B.2 Indonesia, Sumatra, Padang (2009) - Timber frame

Plans and comments

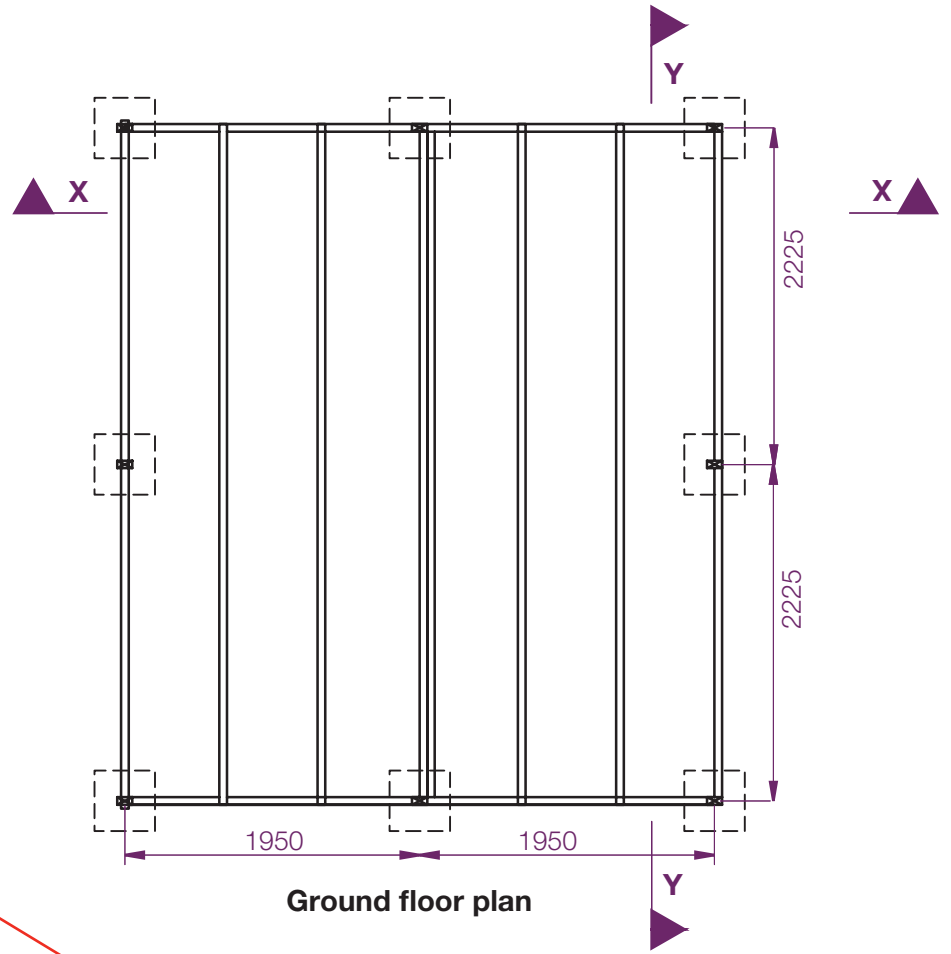
CHECK: The design and detailing of all connections is critical to the stability of the structure. It should be checked for local load cases.

CHECK: The palm matting and thatch has been assumed to be sacrificial or permeable under wind loading. Where walls and roof are upgraded care should be taken to modify the structure to resist the additional wind or seismic loads.

CHECK: If roof or walls are upgraded the roof needs to be strengthened by adding an extra truss and increasing the size of purlins, rafters and the eaves beams.

CHANGE: Add diagonal in-plane bracing to walls to improve lateral stability.

CHANGE: Columns should be properly tied to the foundations to prevent uplift of the structure. If the shelter is upgraded, use embedded base plate foundations or screw in ground anchors ([Section C.1](#)) to resist seismic loads and wind loads.

CHECK: In areas known to have high local wind pressures care must be taken to provide adequate foundations and member sizes to account for this.

Section X-X

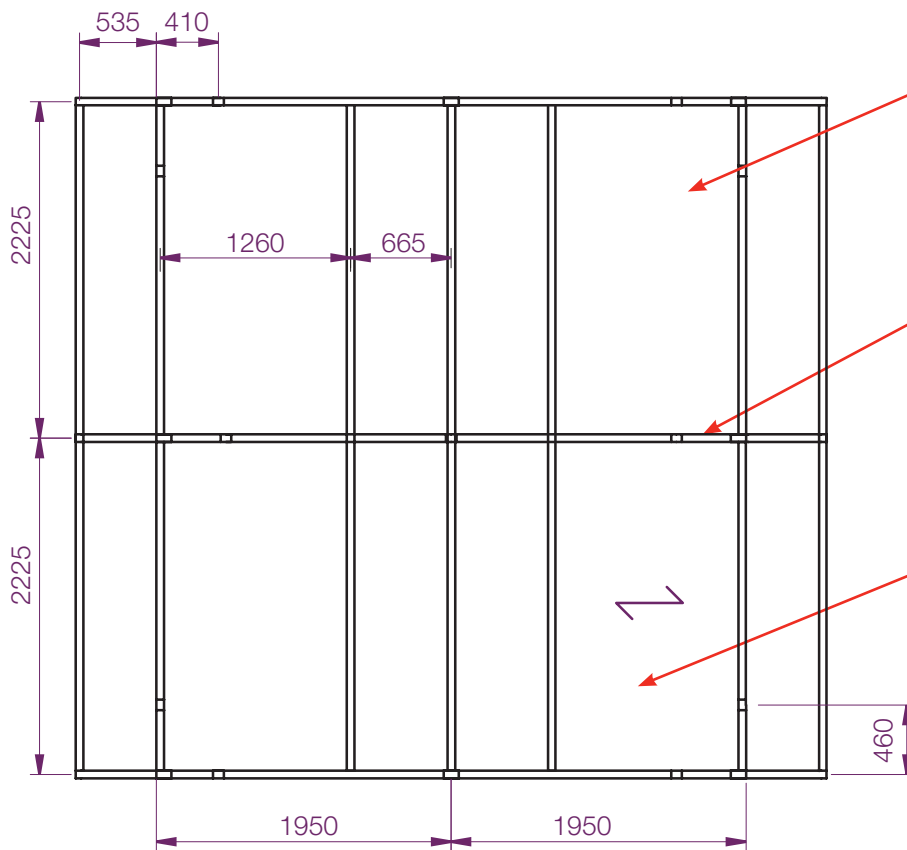
CHECK: Walls can be upgraded using 1/2" thick structural grade plywood (plywood 1 annex I.1.3). We have assumed that vertical framing is spaced at 600mm, and that the plywood is nailed with maximum 150mm spacing. If the wall is upgraded, then vertical framing members must be spaced closer together (24 members total rather than 16).

CHECK: Do not upgrade walls using masonry or cement blocks since heavy materials will perform poorly in an earthquake.

CHECK: Check that the soil type for the shelter location is stiff, otherwise design foundations accordingly.

Roof Level Plan

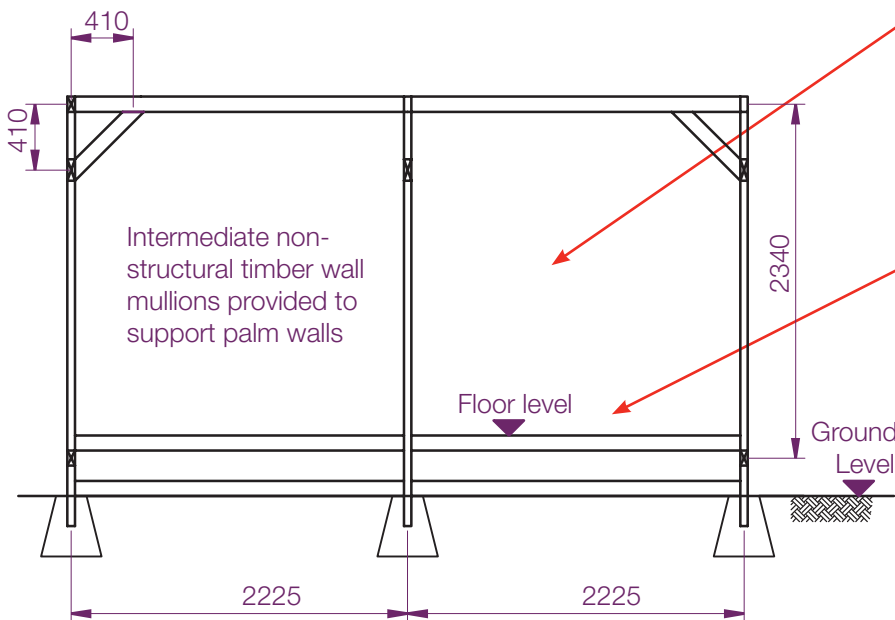
CHANGE: Add bracing in the plane of the roof. Alternatively, use properly nailed roof sheets (see Section C.3) so that the roof acts as a diaphragm.

CHECK: If the weight of the roofing material is increased, the roof member sizes must be re-considered.

CHECK: The roof can be upgraded using corrugated iron sheeting: with a maximum span of 1.5m (Sheet 1, Annex I.1). If the roof is upgraded, then cross bracing will be required in the roof.
